**From:** Gerry Houlder, Seagate Technology <gerry.houlder@seagate.com>  
**Subj:** SAS-2.1 SPL: Add low power transceiver options  
**Date:** Jan. 13, 2009

**SAS-2+ Changes (based on SAS-2 rev.14f):**

Figure new1 – SAS transition to phy power condition

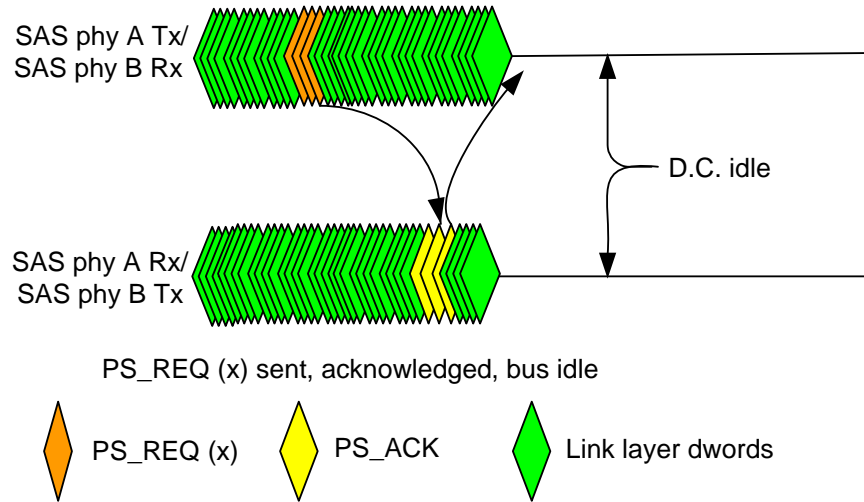
Figure new1 shows the sequence to transition from active to low phy power condition.

Figure new1 shows a transition from both ends transmitting link layer dwords to D.C. idle. The sequence proceeds as follows:

- 1) phy A transmits PS\_REQ (x) primitive to phy B;
- 2) phy B transmits PS\_ACK primitive to phy A;
- 3) both phys remember link rate, training settings, SSC setting, and multiplexing setting;  
and
- 4) both phys transition to the requested D.C. idle.

Figure new2 – SAS COMWAKE wakeup sequence

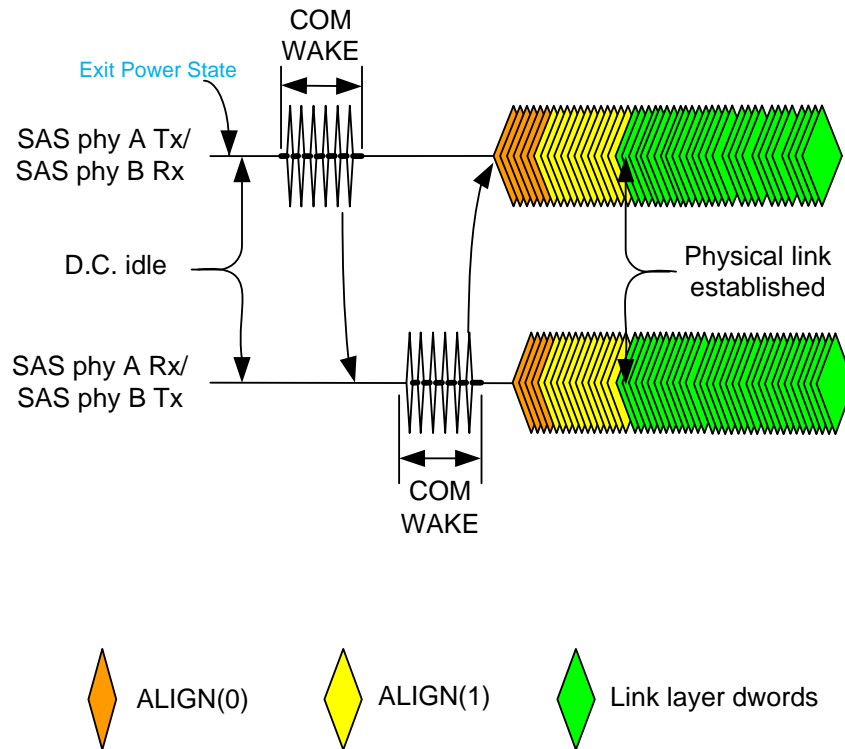
The sequence to recover from either partial or slumber phy power condition is shown in figure new2.

The COMWAKE recovery sequence is as follows:

- 1) phy A initiates exit power management action by transitioning to active condition;
- 2) phy A transmits COMWAKE;
- 3) phy B detects COMWAKE, initiates exit power management action and transmits COMWAKE back to phy A;
- 4) both phys transmit ALIGN (0) primitives at previously negotiated settings;
- 5) when each phy receiver synchronizes on ALIGN (0)s, that phy transmitter changes to transmitting ALIGN (1)s;
- 6) when each phy receiver synchronizes on ALIGN (1)s, that phy transmitter changes to link layer dwords; and
- 7) if phys are multiplexed, the link layer transmits the multiplexing sequence (see 6.7.4.3) to align the logical links.

The link is now re-established with the same transfer rate and SNW3 settings (e.g., SSC mode and multiplexing mode) that were negotiated before the link was placed in phy power condition.

Figure new3 – COMWAKE hot-plug examples

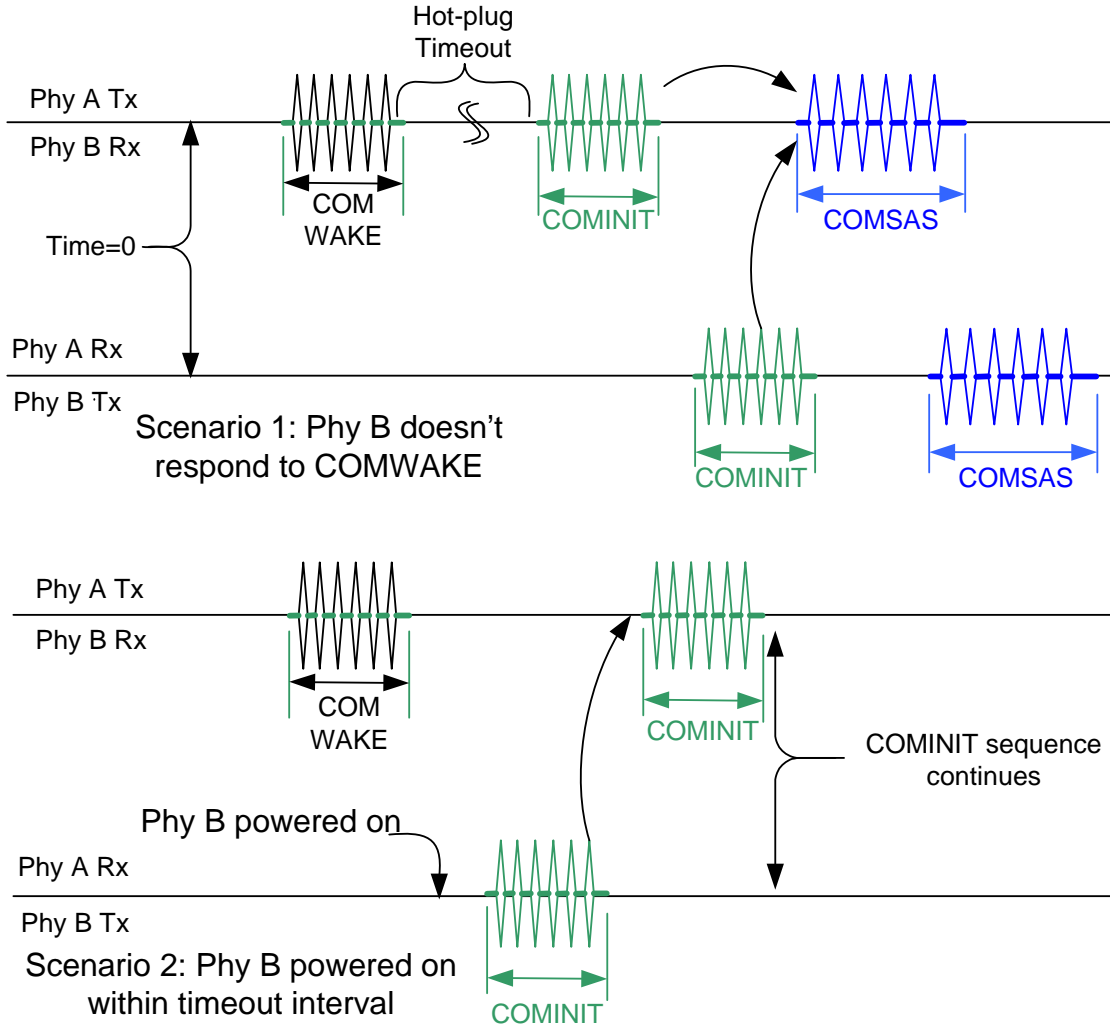
Figure new3 shows examples of hot-plug scenarios that may occur during phy power condition recovery.

Scenario 1 depicts:

- 1) [phy A starting a phy power management exit request;](#)
- 2) [phy B target doesn't respond within timeout limit; and](#)
- 3) [phy A recovers by changing to COMINIT sequence.](#)

Scenario 2 depicts:

- 1) [phy A starting a phy power management exit request;](#)
- 2) [phy B is powered on and begins COMINIT sequence within the timeout limit; and](#)
- 3) [phy A proceeds by continuing the COMINIT sequence.](#)
